ZONING BOARD OF APPEALS

WEDNESDAY August 7, 2024, @ 6:30 P.M.

a. Planning Department report

SITE PLAN

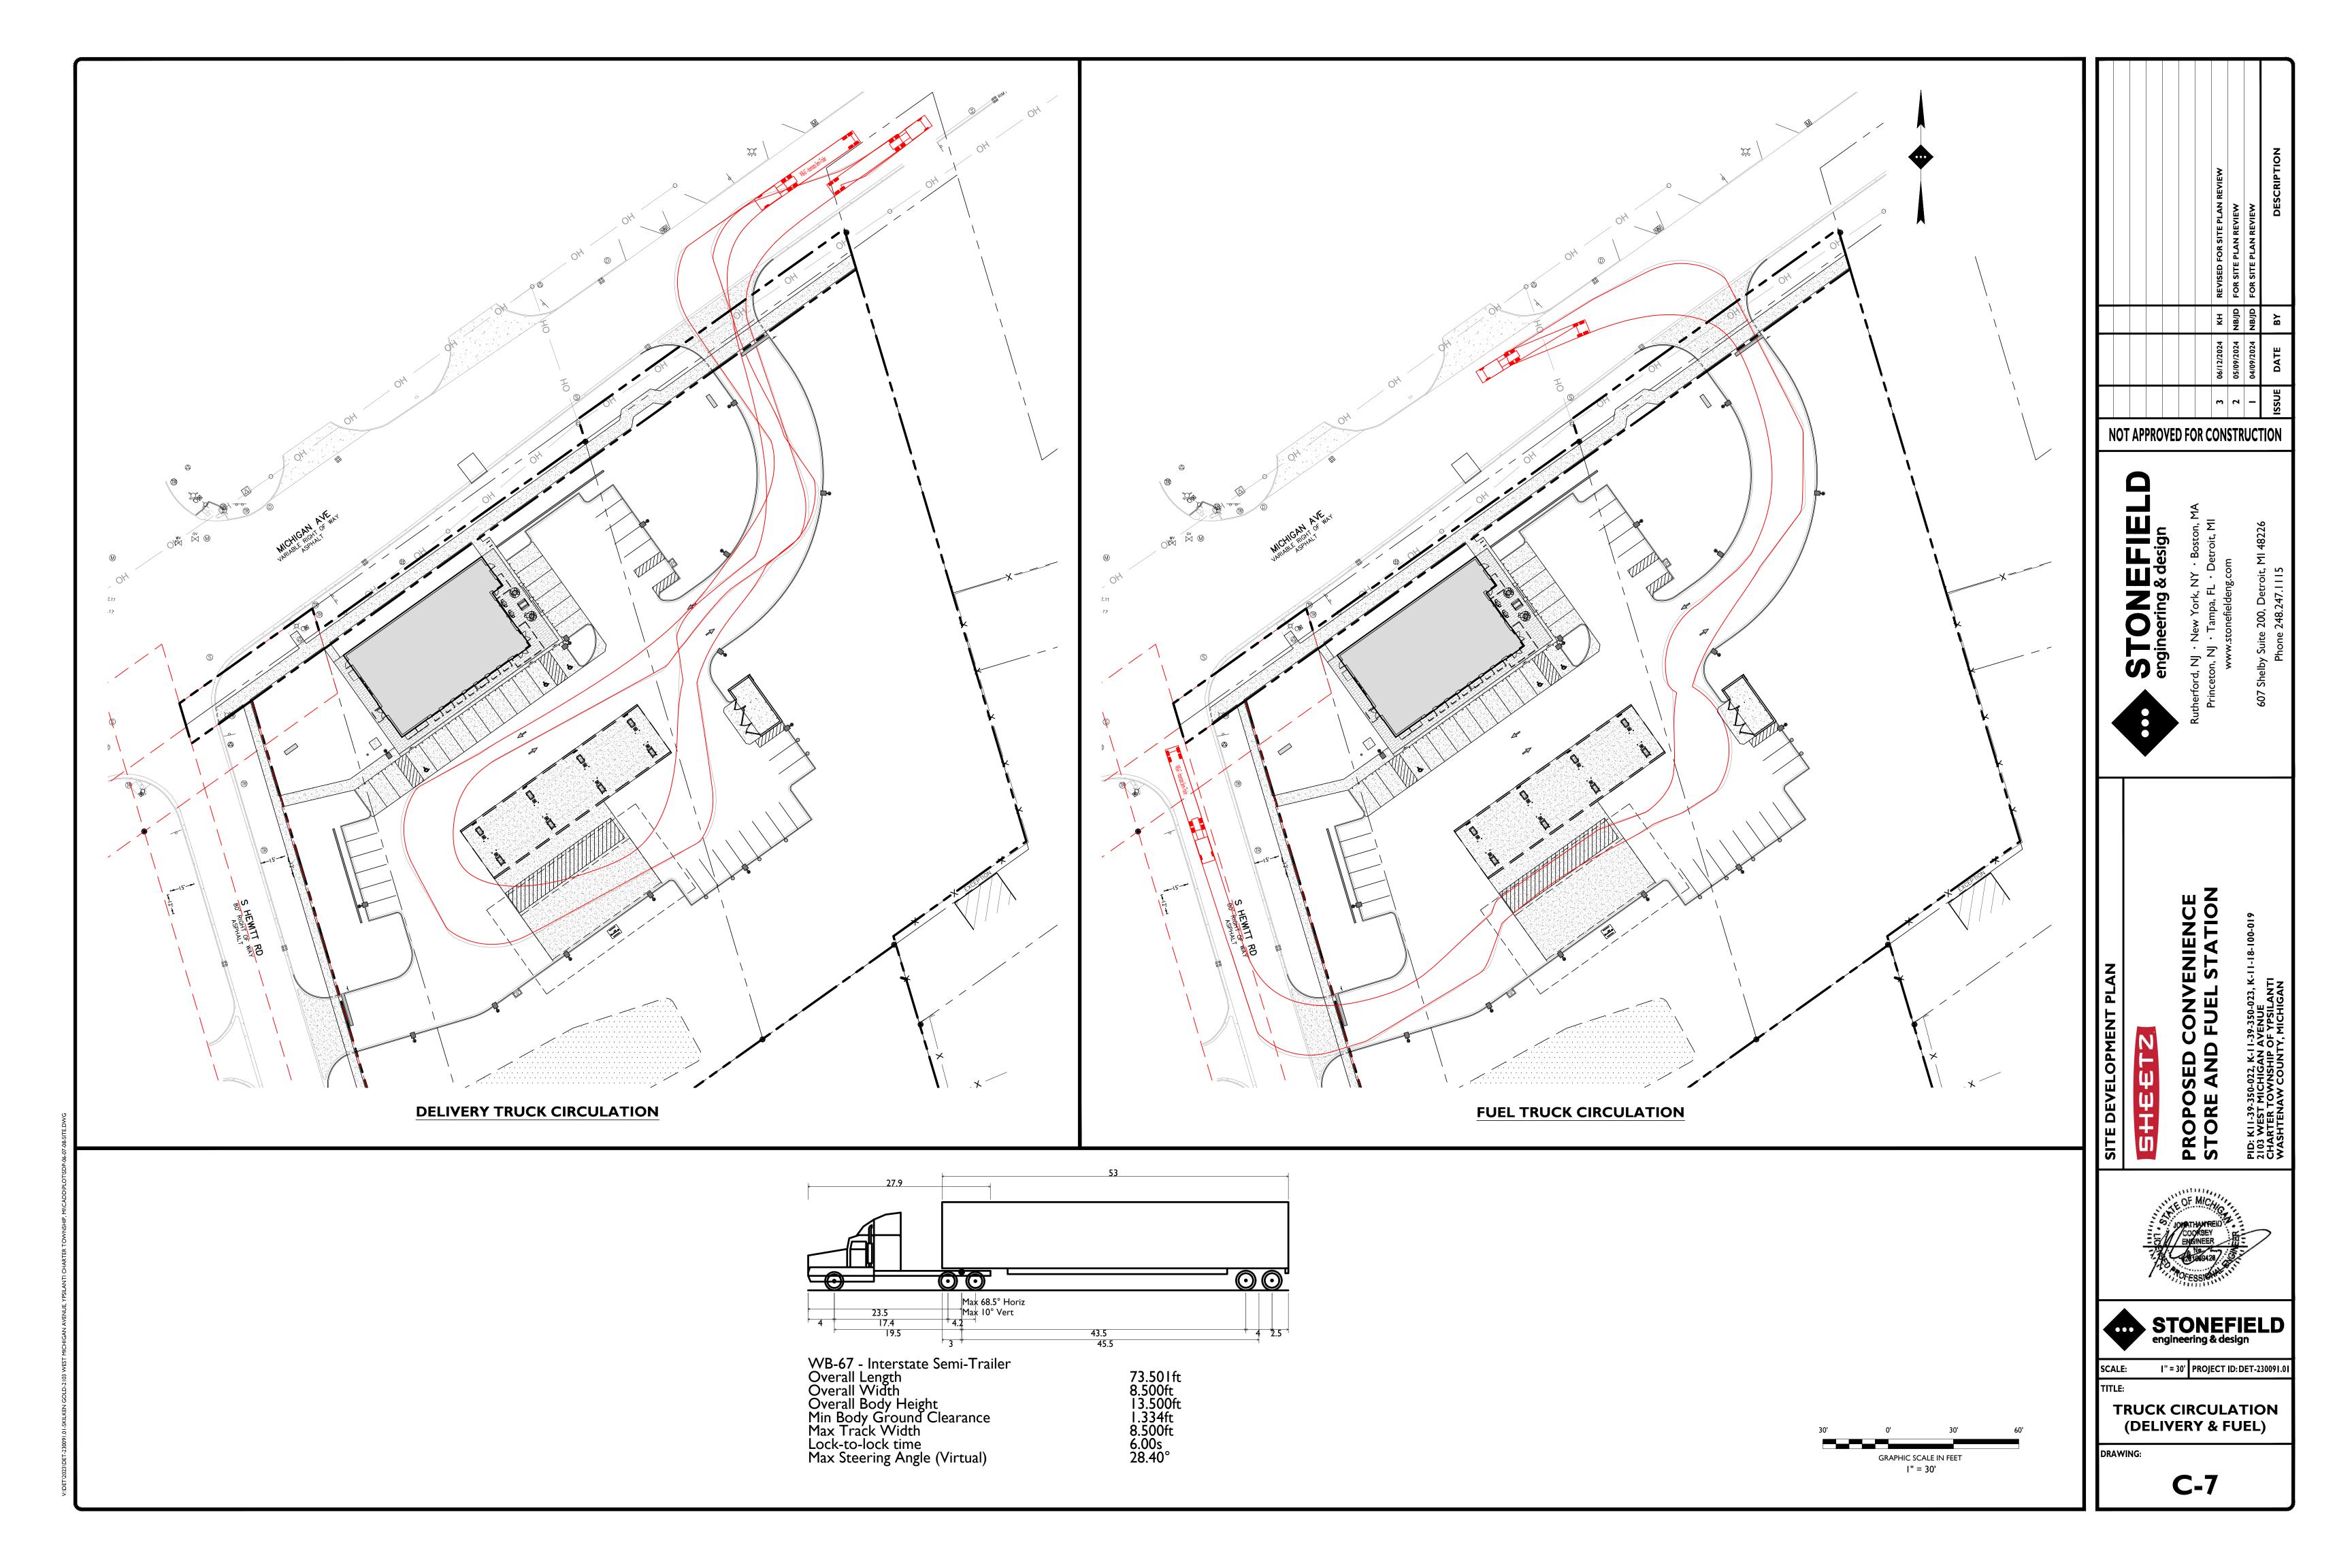
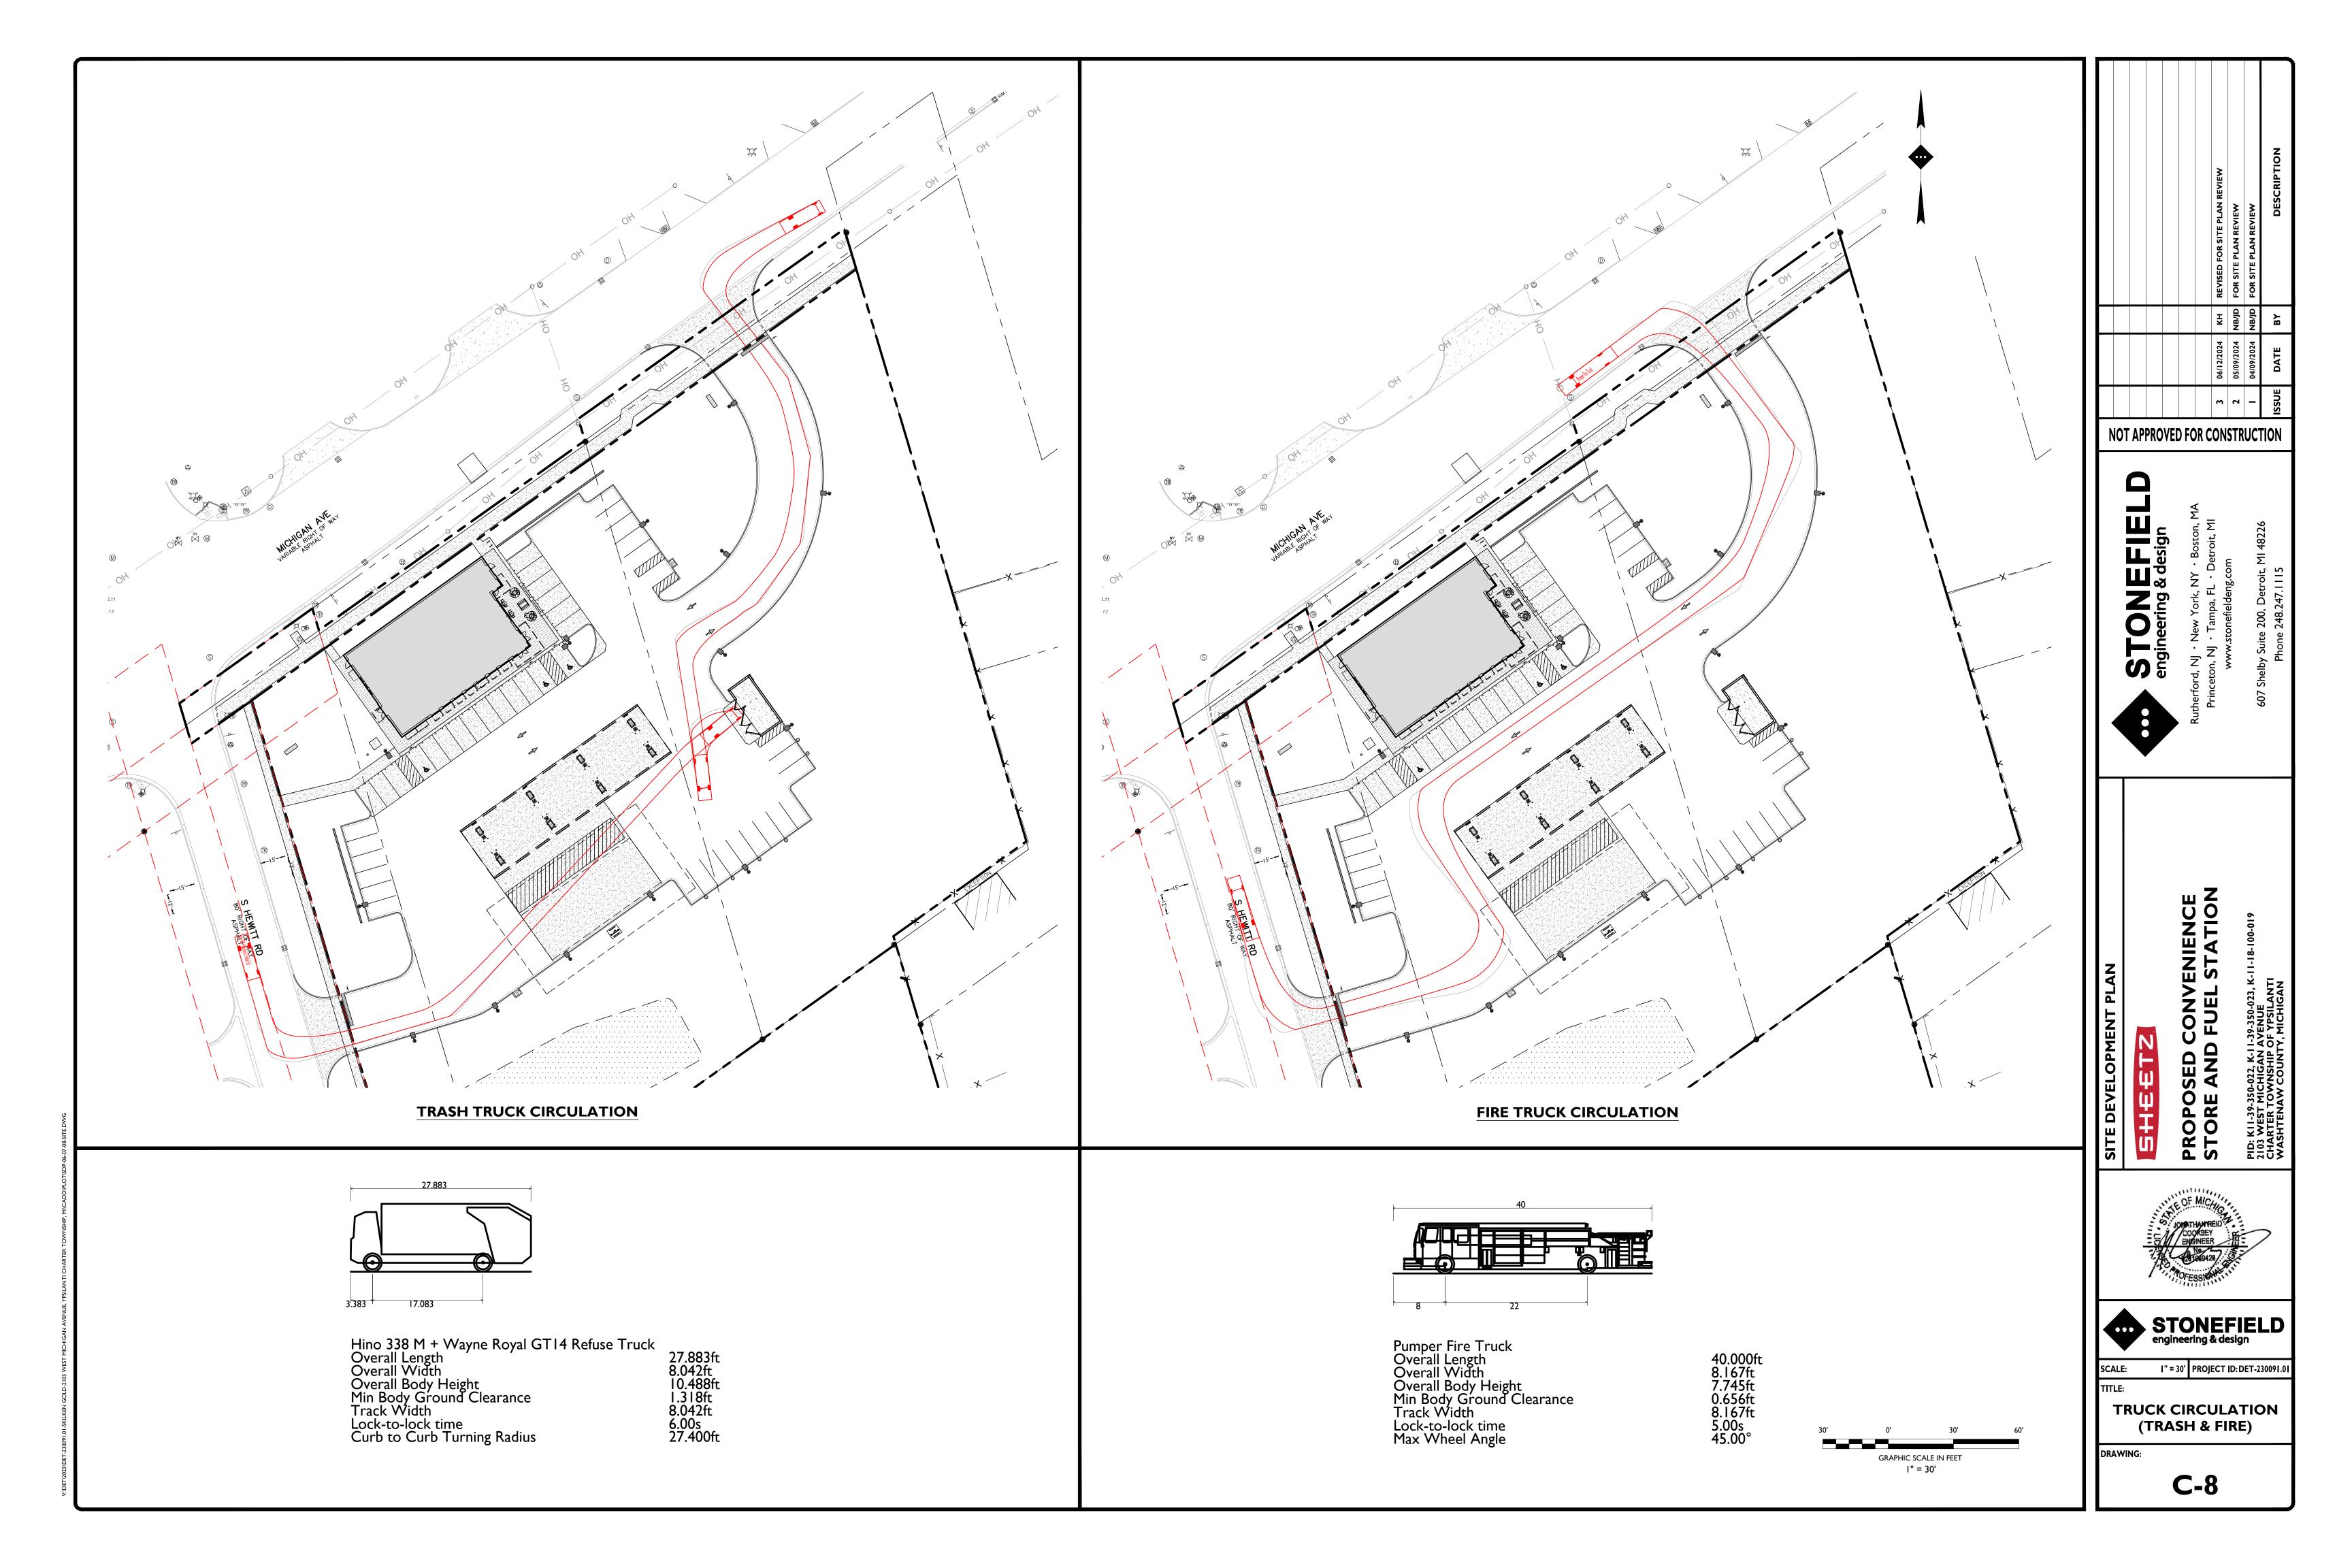
Building Location: The site is occupied by a road easement in the northwest corner, as shown on Sheet C-6. The ordinance requires that the building be placed at the 10-foot build-to-line, which is the line 10-feet from the front property line along a street. Because of this road easement, the building cannot be located 10-feet from the S. Hewitt Rd. property line. Therefore, special circumstances exist on this property that make compliance with the ordinance for building location impossible.

The applicant has not provided any floor plans to show how the interior of the building coordinates with the location of doors and windows. Floor plans should be provided with the variance request to allow the Zoning Board of Appeals to confirm windows/doors would interfere with these facilities.

However, regarding the transparency variance requests, the applicant should provide/respond to the following:

- 1) Floor plans should be provided with the variance request.
- 2) <u>W. Michigan Ave. Transparency Variance</u>. The applicant should respond to the following, and offer other options to increase the transparency on the W. Michigan Ave. façade:

- c. Has the applicant considered allowing customers to view the activity in the food preparation area?
 - d. Would it be possible to add a pedestrian door on the W. Michigan Ave. side of the building?

- 3) <u>S. Hewitt St. Transparency Variance</u>. ZBA and applicant to discuss flipping the orientation of the building, and locating the patio (with the associated window/door configuration) on the west side of the building, facing S. Hewitt. Benefits this could provide include:
